**Power supply, 998-0248 is no longer available.
400-5421-05024 is the replacement.**

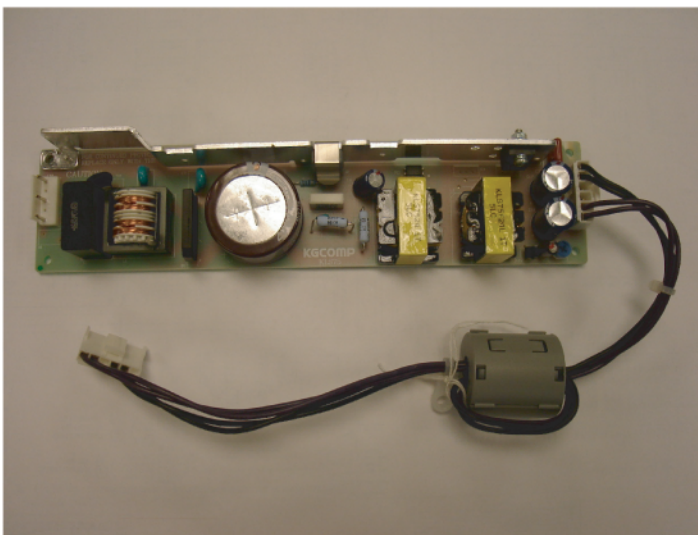
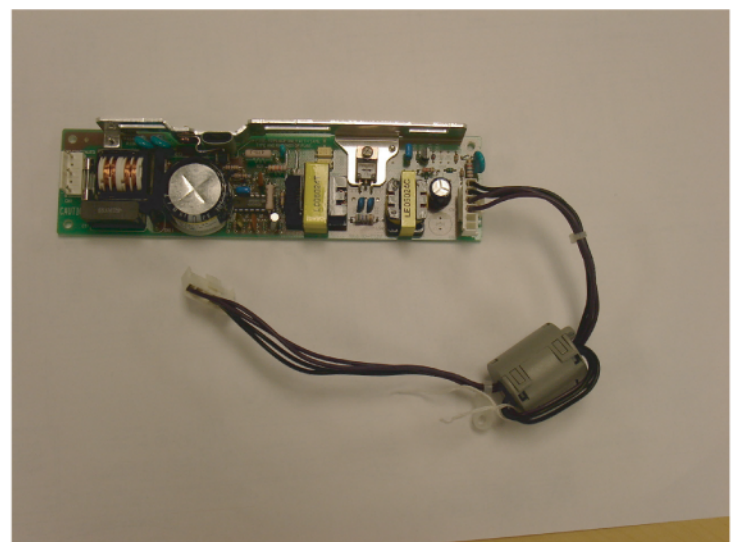
Before using this new power supply you will need to re-wire the 6 pin harness connector(CN2)
Use the information below as your guide.

**REMOVE THE 2 PURPLE WIRES FROM
CONNECTOR (Use small screw driver)**

**MOVE THE 2 PURPLE WIRES TO PIN 3
& PIN 4 IN THE CONNECTOR**
